Intel® High Definition Audio Specification

Document Change Notification

Change Identification: **DCN No: HDA015-B**
Document Revision: Intel® High Definition Audio 1.0

Title: Low Power Capabilities Clarifications and Enhancements

Figure F1. Power State Field Definition

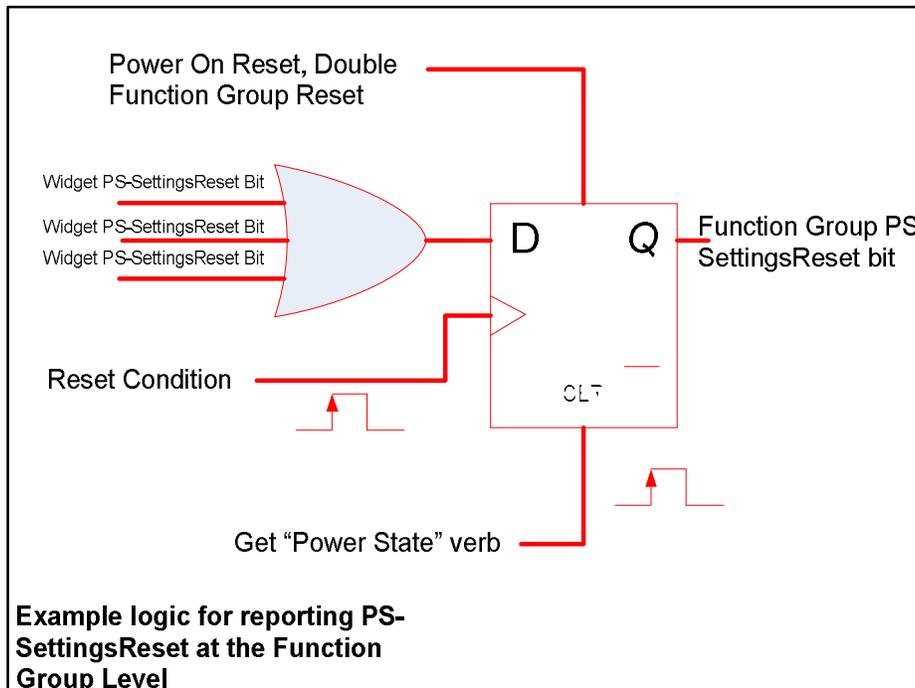
The PS-SettingsReset bit for individual widgets, will be cleared to zero (0) on receipt of any “Set” verb to that widget; or After responding to a get Power State verb, to that widget, with the response containing PS-SettingsReset set to one (1).

The PS-SettingsReset bit for the Function Group is handled differently than at the widget level. For the Function Group the PS-SettingsReset is set to one (1) when any widget sets its PS-SettingsReset to one (1). The Function Group PS-SettingsReset bit is thus the logical “or” of all the EPSS bits, but is latched so that it can be reset independently and not require that all EPSS bits be reset.

The PS-SettingsReset bit is 'sticky'. Once set, it will retain its value until it's cleared by a 'Get' verb, regardless of other single or double Function Group resets, Dx state transitions etc that may occur in the meantime.

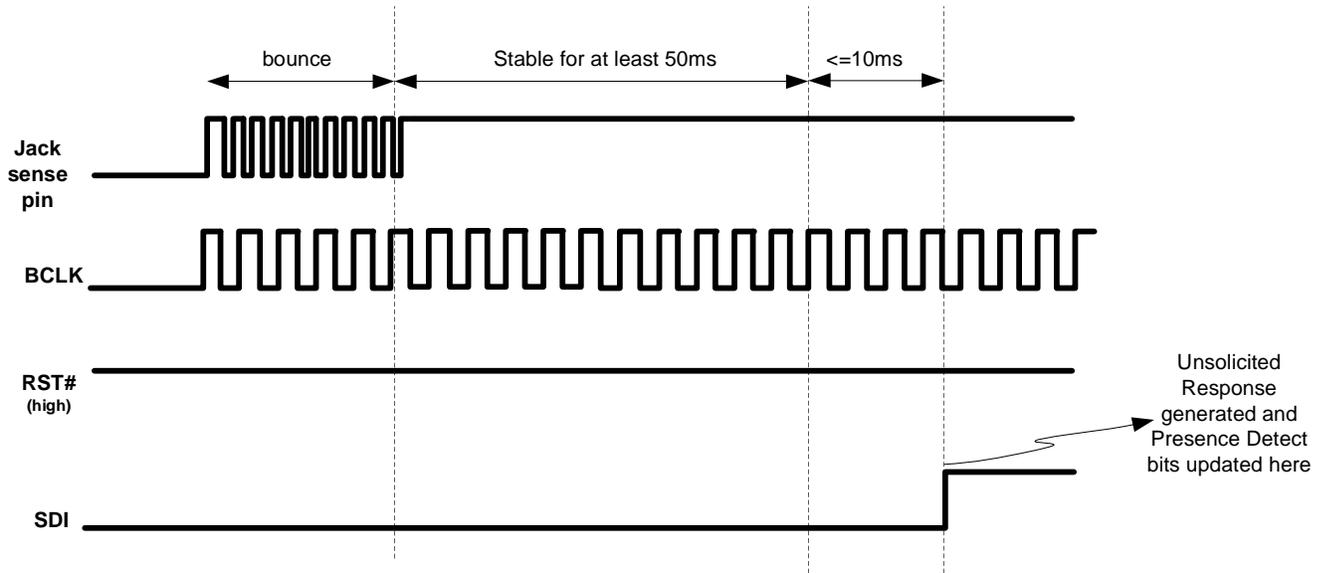
- States for the Function Group CLKSTOP in its Supported Power States response.
- 6) Supported Power States command (Verb) is required for all widgets that report PowerCntrl bit set to 1 in their Audio Widget Capabilities response. Widgets that would report EPSS of 1, but not PowerCntrl of 1 is not permitted.
 - 7) Follows the rules for settings persistence outlined in Table T2, for the widget reporting EPSS of one (1).

7.4.2 Audio Jack Detection Circuits

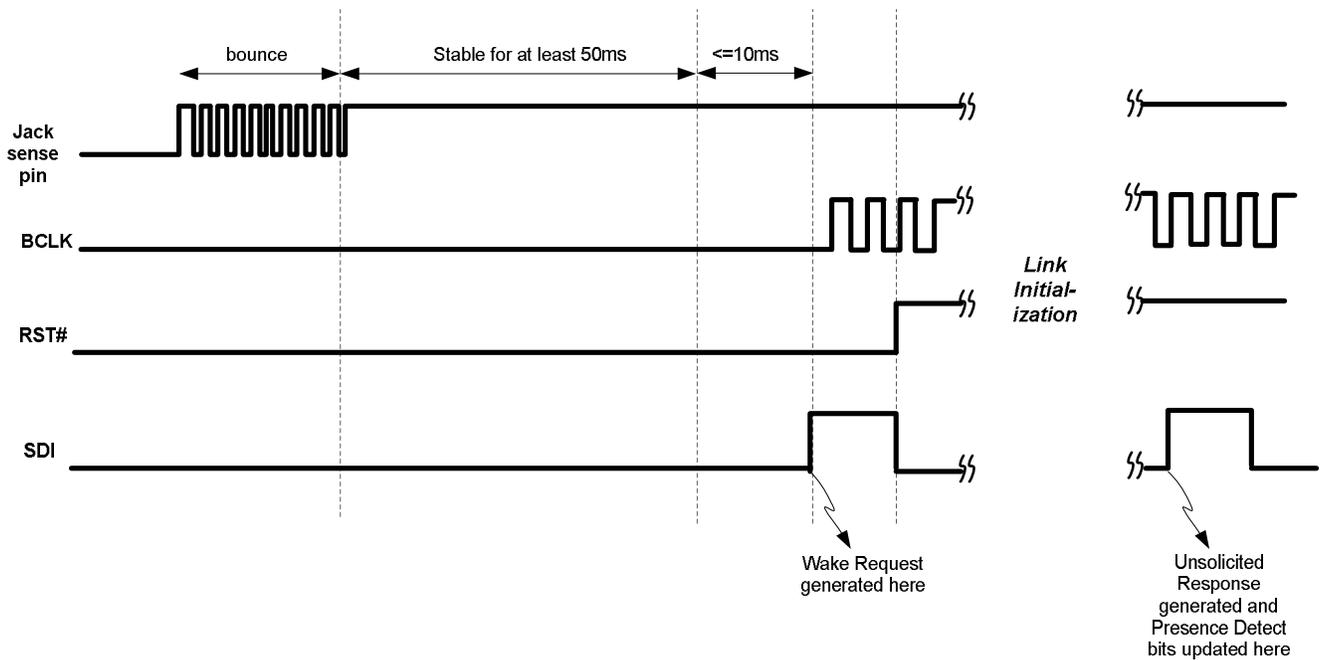
When detecting the insertion or removal of a jack, where the impedance of a shared sense line is being used, the codec shall measure the impedance of the jack's presence detect precision resistors continuously to determine when to report a change of state. Reporting of state change and change in the presence detect state bits shall not occur until any impedance (does not preclude other measurement techniques) change has initially stabilized for at least 50 Milliseconds. From the point at which the impedance has stabilized the codec shall report an Unsolicited Response, if enabled and the High Definition Audio Link clock is running, within 10 Milliseconds. If this clock is not running, then the request to wake the Link shall occur within 10 Milliseconds. Thus any presence detection logic used to detect which resistors are switched in for the purposes of Presence Detection, must operate more quickly than 10 Milliseconds. Once the unplug or plug event has been signaled to the host through the unsolicited response, another event or change of the presence detection bits shall not be generated unless the opposite jack state has been sensed (detected) continuously for at least 50 Milliseconds. The state of the Presence Detect bits for all the jacks associated with a shared sense line shall not change until the point where an Unsolicited Response could be generated, if disabled,

or is generated when enabled. Thus the state of the Presence Detection bits should be “de-bounced” with hysteresis of at least 50 Milliseconds, but longer times are permissible as long as the initial state change and reporting time is met. When the codec has returned to D0 from any lower power state, the state of the presence detection bits must be correct. If the codec power has been removed and the state of the presence detection bits has been reset, the codec shall report this by setting the PS-SettingsReset bit for the affected Pin Widget(s). The timing specifications described above are demonstrated in the following diagrams:
